BARBARICK WASTE TRANSFER STATION

LETTER OF INTENT

PCD FILE NO.: COM2346

FINAL DRAINAGE REPORT COMMENT RESPONSE

DETENTION BASIN OUTLET STRUCTURE DESIGN

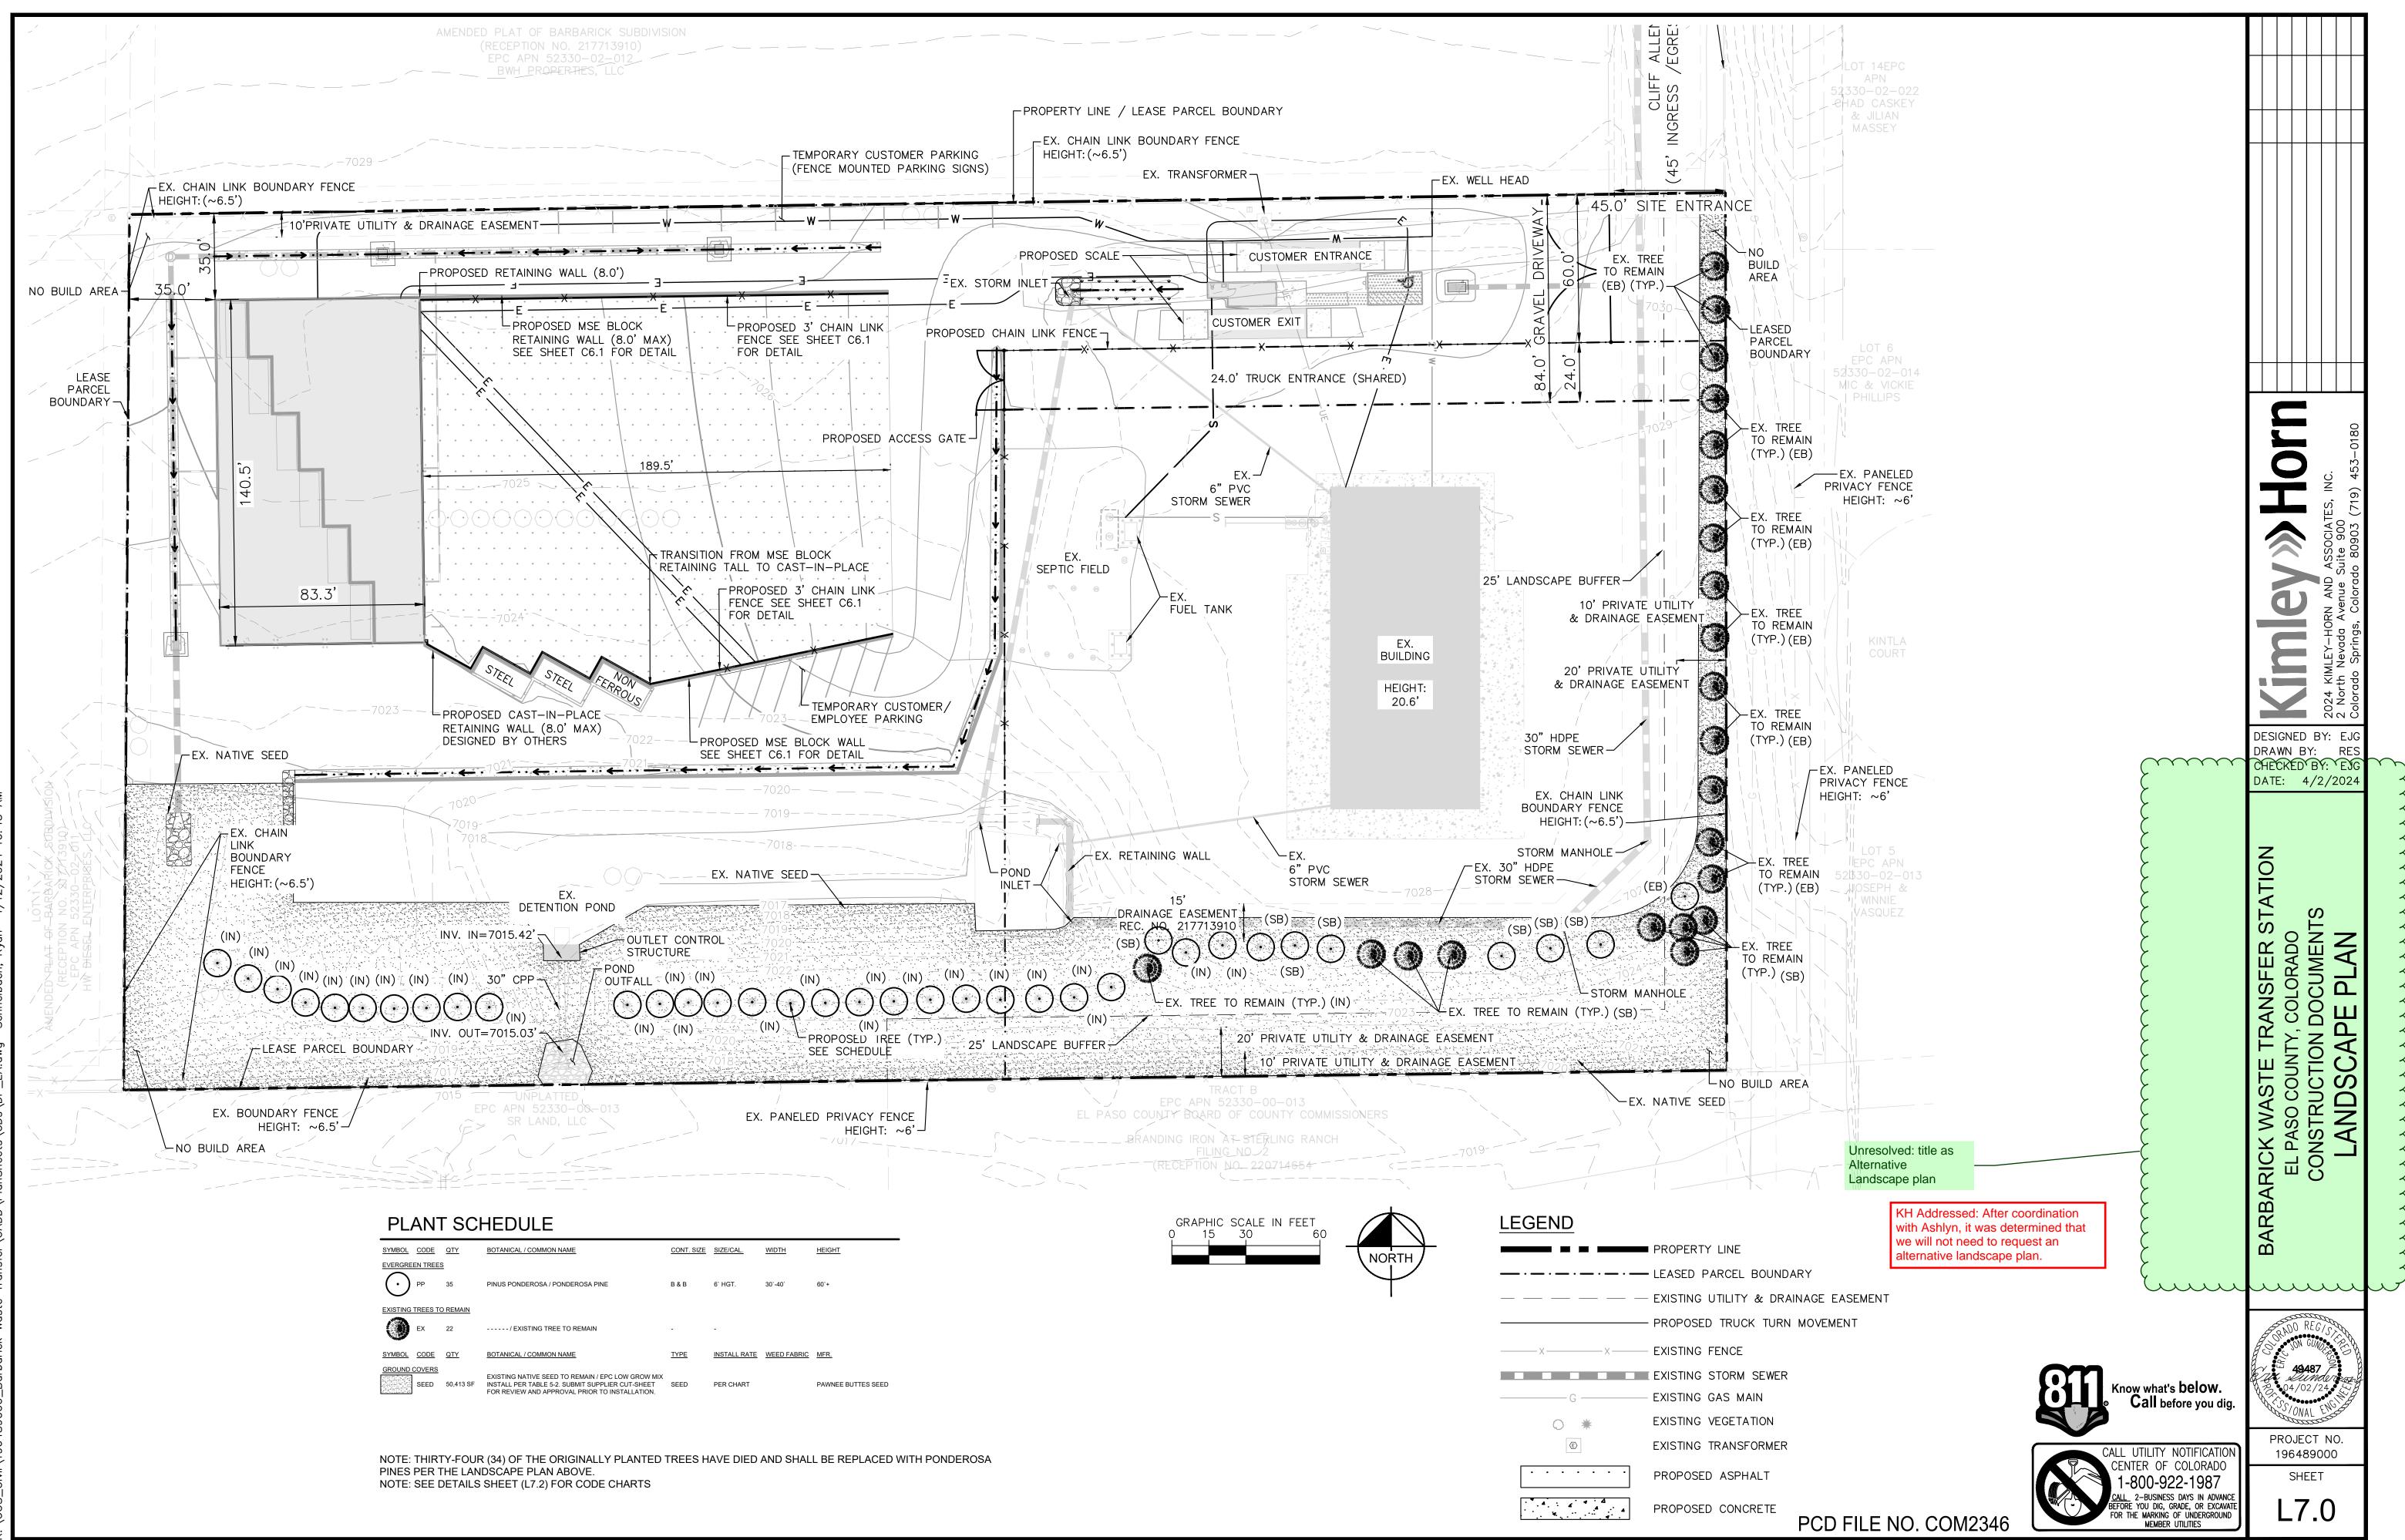
Stage = 0ft at 7016.5, per pg 61 of FDR. Then per this page, the "Depth to Invert of Outlet Pipe" is 1.02ft below Stage = 0ft which would be 7015.48ft. But on Sht C3.0 (pg 8) of 他的。 the invert is labeled as 7015.42ft. So depth in these MHFD calcs should be 1.08ft.

0.56	0.47	0.52	0.56	0.57	0.58	0.60
Good catch! We have	/e address	sed <u>1.248</u>	0.822	1.064	1.265	1.333	1.384	1.502
and modified the res	strictor pla	te 🛛 🗖	comment generated	due to Kimley	s response to r	ny comment in	the previous of	ibmittal:
accordingly.			similarit generateu	due to ramey		iny comment in	ine previous st	ornittel.
accordingly.		S	tage = 0ft at 7016 5	per pg 61 of l	EDR Then per	this page the "	Depth to Invert	of Outlet
